UNITED STATES PATENT AND TRADEMARK OFFICE

APPLICATION NO.	FILING DATE	FIRST NAMED INVENTOR	ATTORNEY DOCKET NO.	CONFIRMATION NO.
10/646,611	08/22/2003	Guy Simon Dawson	37261P087	9810

Office Action Summary	Application No. 10/646,611	Applicant(s) DAWSON, GUY SIMON	
	Examiner Vinh T. Luong	Art Unit 3682

ATTACHMENT

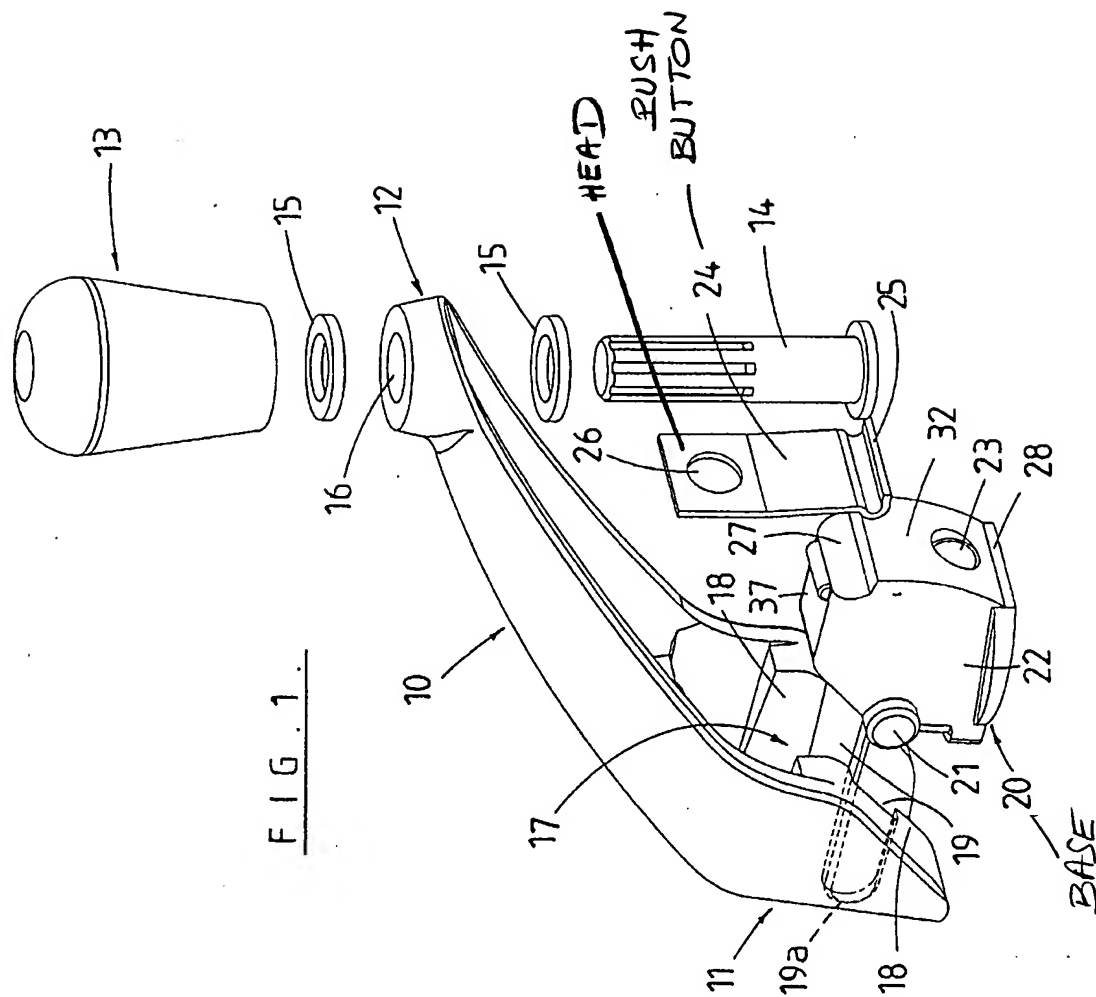
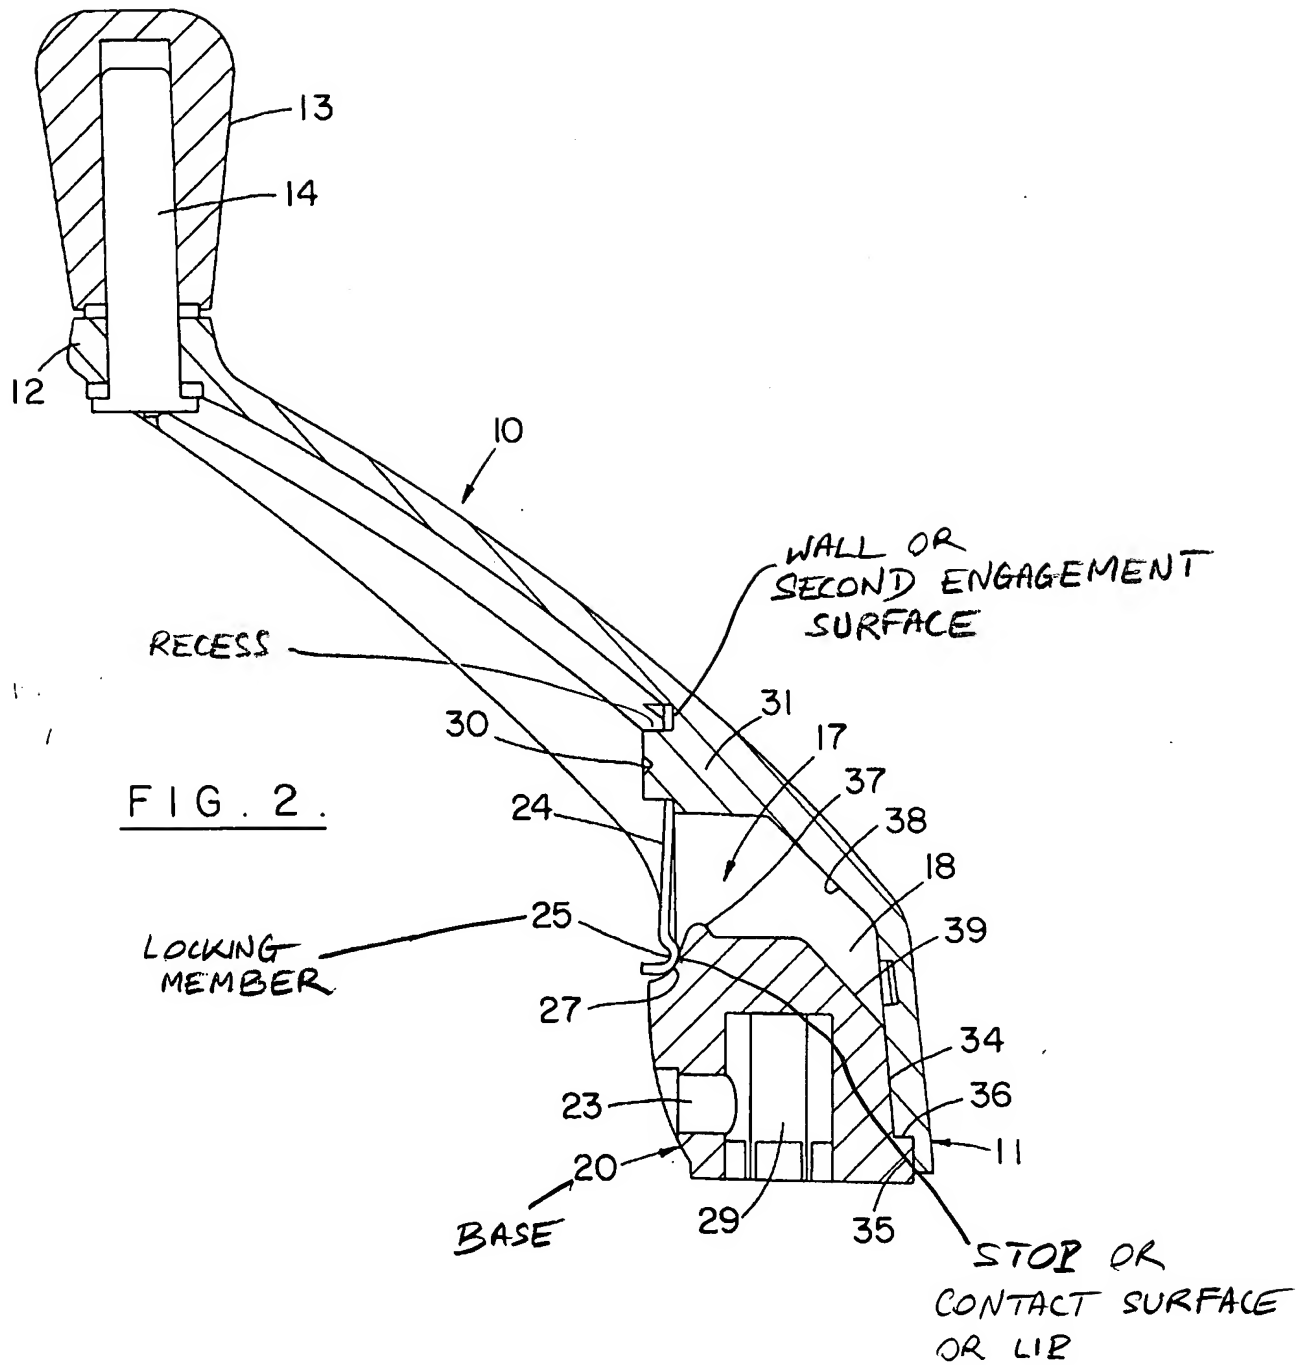
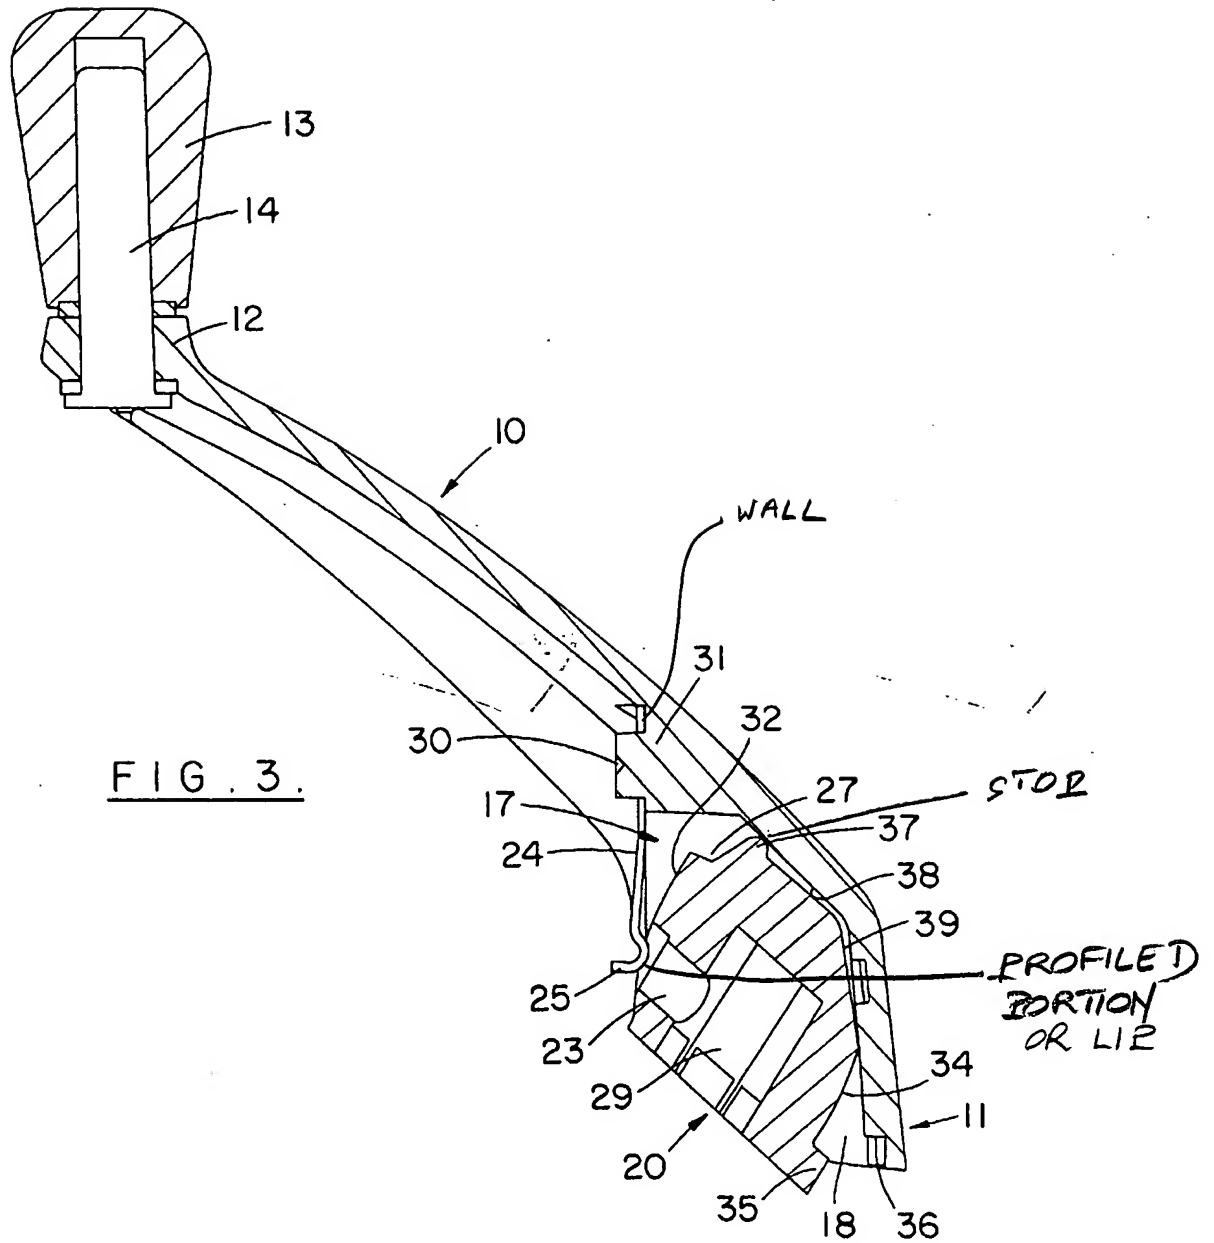
Regarding claim 2, the push button 24 includes a head (see Fig. 1 in the Attachment), which is slidably located in a recess (Fig. 2, Att.) the handle member 10.

Regarding claim 3, the peripheral shape of the recess (Fig. 2, Att.) substantially corresponds to a peripheral shape of the button 24.

Regarding claim 7, see a stop 25 (Fig. 2, Att.) to prevent movement of the locking member 25 under action of the biasing mechanism 24 from moving beyond the locking position (Fig. 2). *Ibid.*, col. 3, lines 7-25. Alternatively, see a stop 37 (Fig. 3) to prevent movement of the locking member 25 under action of the biasing mechanism 24 from moving beyond the locking position.

Regarding claim 10, the locking member 25 includes a profiled portion 25 (Att.), which provides a clearance (at 23 in Fig. 3) between the locking portion 25 and the pivot base 20 when the locking member 25 is in the release position (Fig. 3).

Regarding claim 11, the profiled portion 25 includes a contact surface (Att.), which contacts a profiled surface 27, 28 of the pivot base 20 during movement of the handle between the first and second positions (Figs. 2 and 3).

Regarding claim 13, the recess (Fig. 2, Att.) includes a contact surface 30, which is contacted by the head (Fig. 1, Att.) when the locking member 25 is in the release position.

Regarding claim 18, the lip 25 projects from the locking portion 25. The engagement surface 30 is formed by a wall (Att., Figs. 2 and 3) in the handle member 10. The wall (Att.) further forms a second engagement surface (Att.). The locking portion 25 of the locking member 25 is located between second engagement surface (Att.) and the pivot base 20 to create the blocking action.
